Subject: AP1000 Response to Request for Additional Information (SRP TR03)

Response to Request for Additional Information on SRP Section TR03

RAI Response Number: RAI-TR03-022
Revision: 4

RAI Response Number: RAI-TR03-037
Revision: 2

Figure RAI-TR03-022-01 – Comparison of Time History Displacements using Double Integration and Fast Fourier Transforms

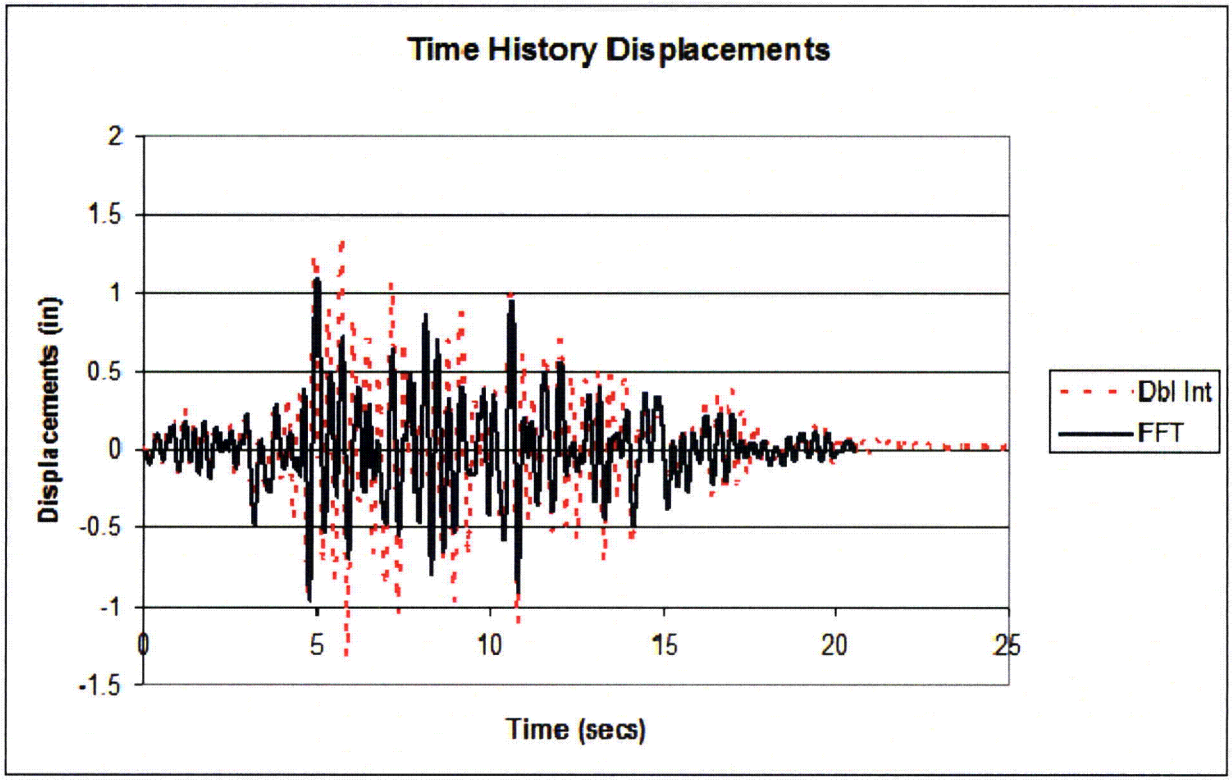
a. Are the deflections in the tables a consistent set, based on the worst-case time history result, or are they an envelope of maximum deflections from all the time history results?

a. During the October 8-12, 2007 audit, the NRC requested that Westinghouse consider adjusting the deflections obtained from SSI analyses for drift in the frequency domain, and not use a baseline correction that subtracts the slope of the relative displacement multiplied by the time from the relative displacement at each time step. Westinghouse has adopted the recommended approach by calculating displacements internally within the SASSI program based on an analytical complex frequency domain approach that uses inverse fast-fourier transforms (FFT) to compute relative displacement histories instead of double numerical integration in the time domain for computing absolute displacement time histories from absolute acceleration time histories. The analytical approach is more accurate than a typical baseline correction (time integration) algorithm.

In Figure RAI-TR03-022-01 is presented a comparison for the baseline double integration(old, Dbl Int) method compared to the FFT (new method) shown for the soft to medium soil case at the top of the shield building.

> "The relative displacement time history is calculated using ACS SASSI RELDISP module. The complex acceleration transfer functions (TF) are computed for reference and all selected output nodes. The relative acceleration transfer function is calculated by subtracting the reference node TF from the output node TF. The relative displacement transfer function is obtained by dividing the circular frequency square (ω^2) for each frequency data point. The relative displacement time history is obtained by taking the inverse FFT."

Figure 3G.4-5X:X Direction FRS for Node 130401 (NI10) or 1761 (NI20) CIS at Reactor Vessel Support Elevation of 100′

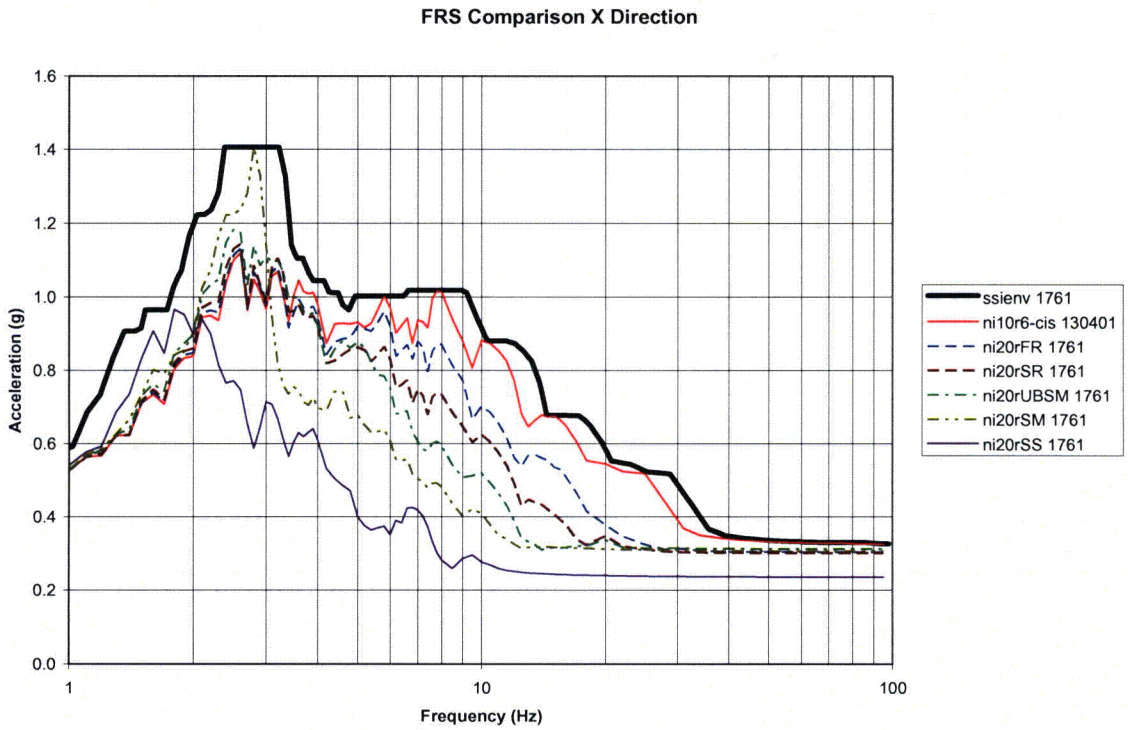
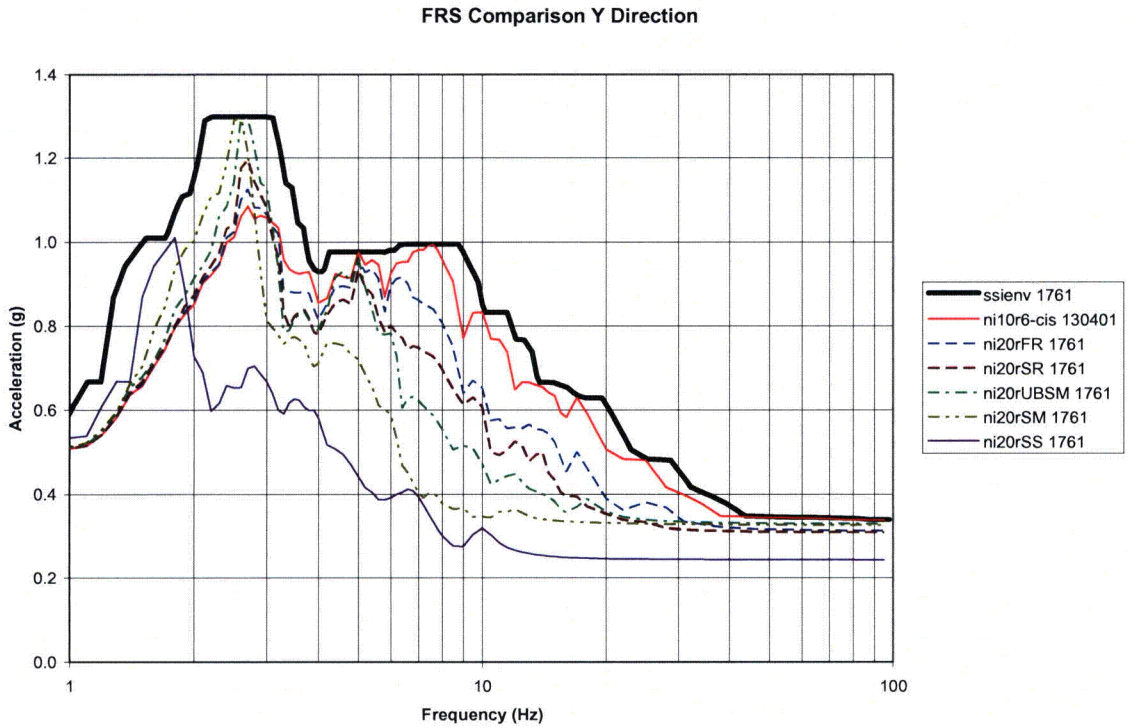
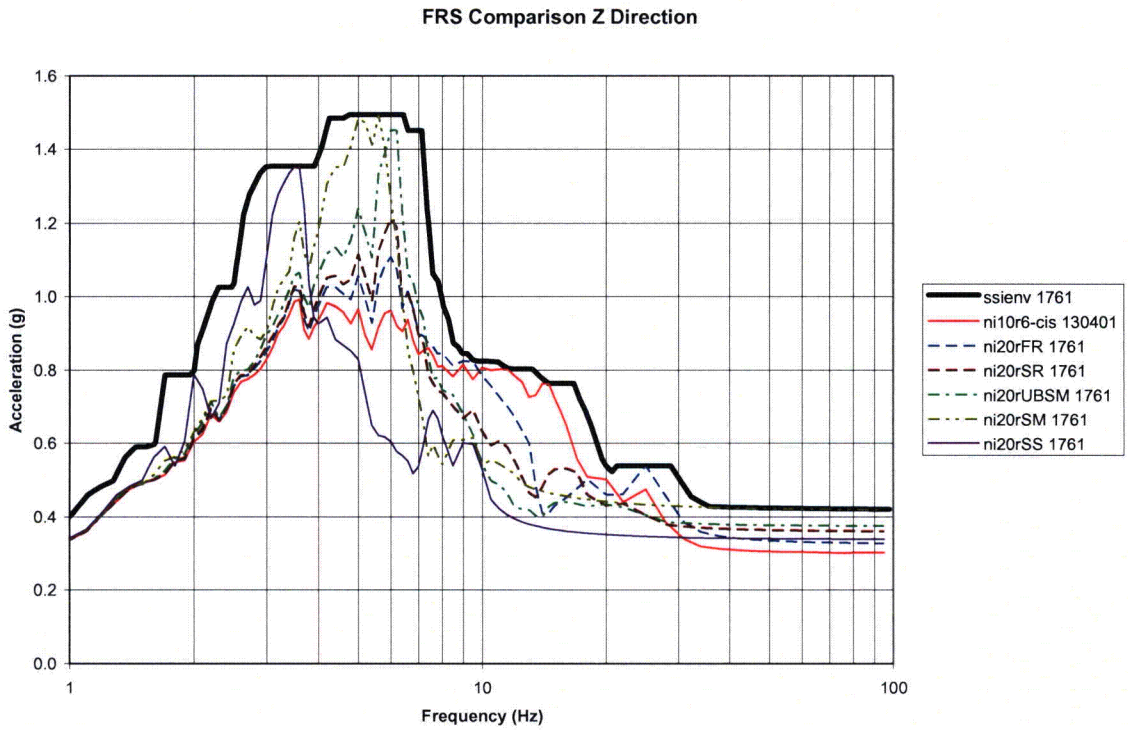
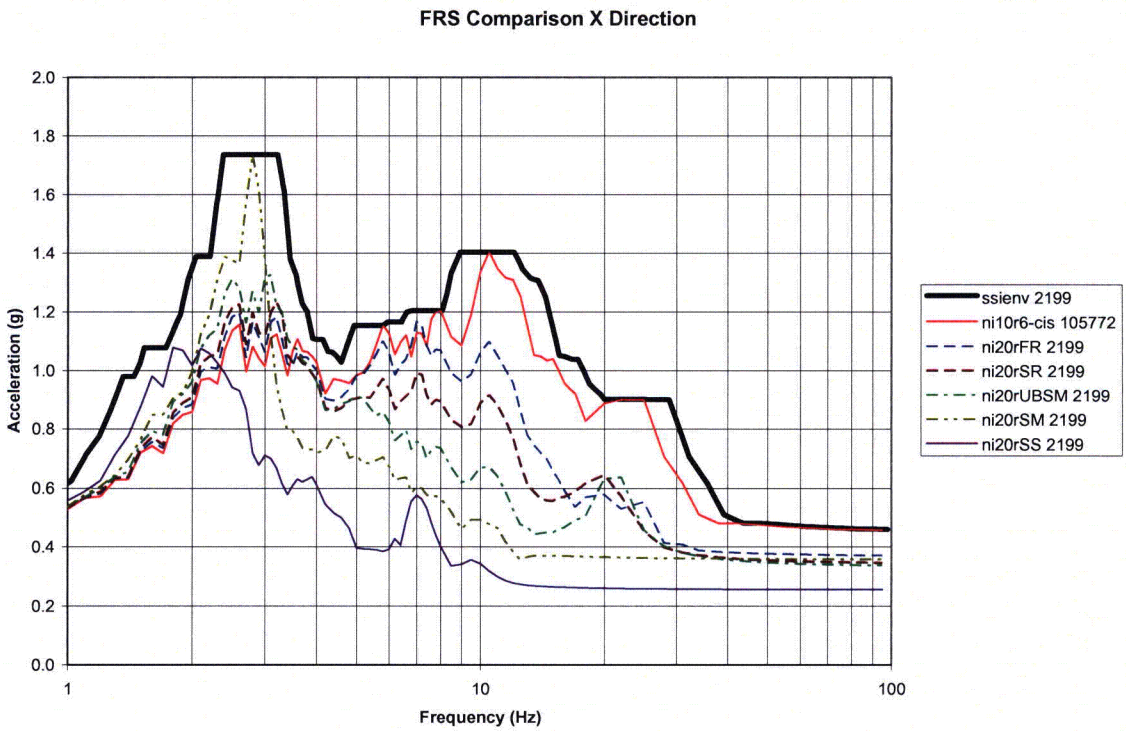
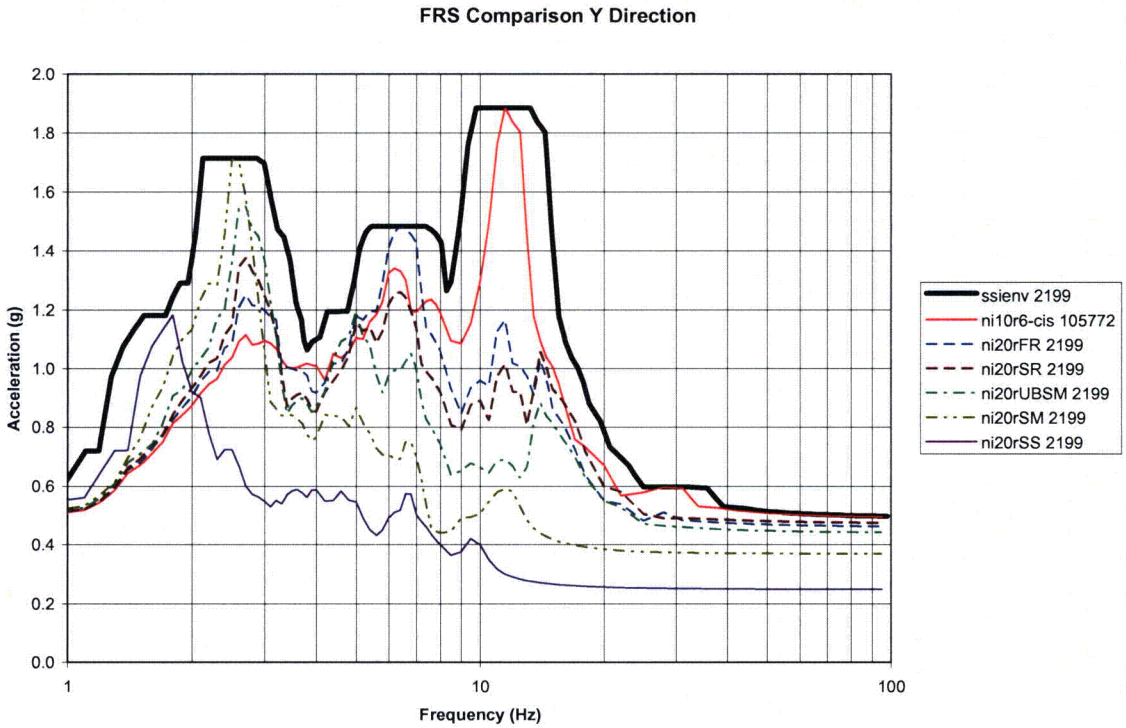
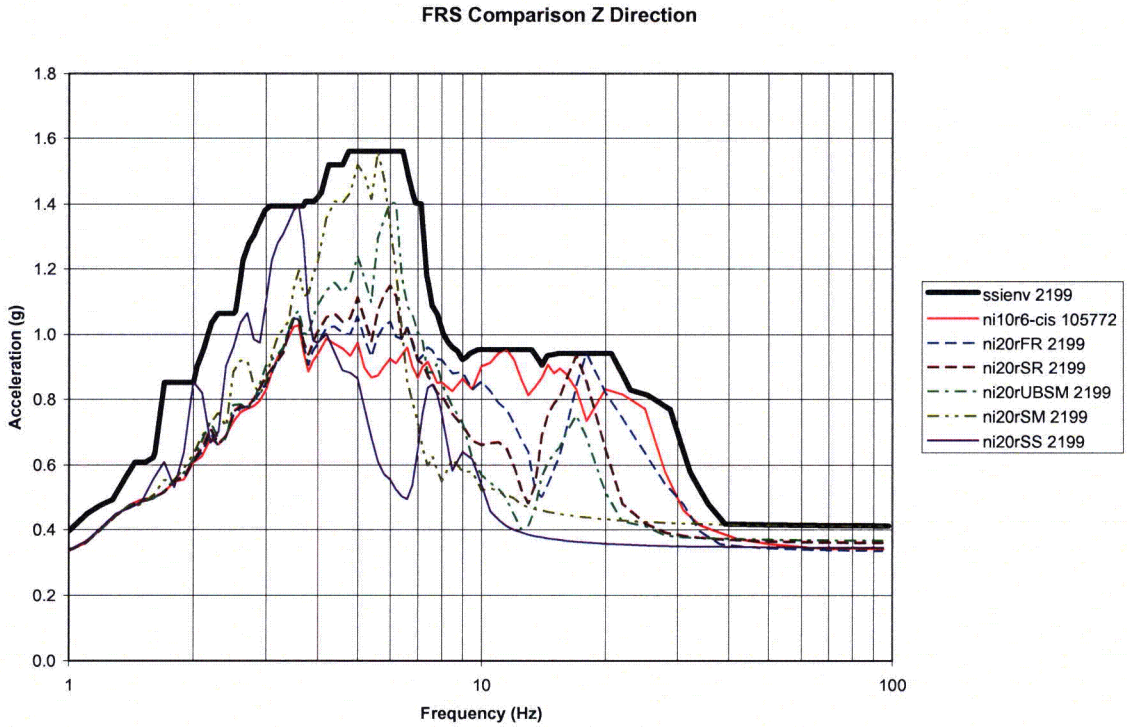
In TR-03, Revision 4, Section 4.4.1.2, the applicant added a new soil case for the deep soil site, and indicated that the deep soil site profile uses a unique input time history that is only used to develop in-structure design response spectra. The staff is unclear about how applicant would include this case as part of the seismic design basis. In TR-03, the deep soil site is not fully characterized nor is it clear regarding how the SSI analysis was performed using the CSDRS as the ground motion input. Therefore, the staff requests the applicant to provide a detailed description of the deep soil site condition, and provide the SSI results and justification for its application to the AP1000 design response spectra (CSDRS).

- Appendix E – Remove the deep soil case from Figures 3G.4-5X to 3G.4-10Z as shown below:

The deep soil site is removed from Technical Report (TR-03). If applicable, a deep soil site will be considered within a COL application. The changes to TR-03 are identified in the Technical Report (TR) Revision sections below. In DCD subsection 3G.4.3.3, a sentence is added to recognize that the design seismic response spectrum is conservatively adjusted in the low frequency range.
